# Technical Notice

IPX-13S-RS-R40

Running change

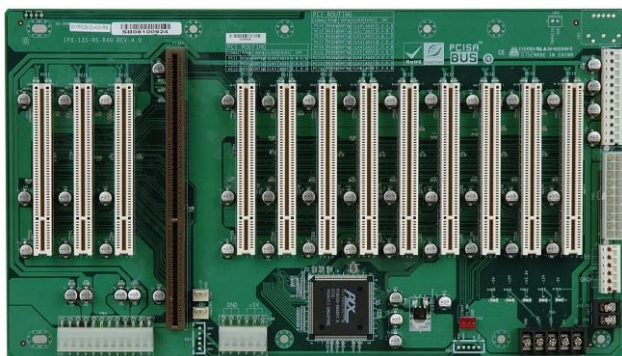
Due to the EOL of PLX PCI6150-BB66PC

Add Pericom PI7C8150BMAE as the substitute of PLX PCI6150-BB66PC.
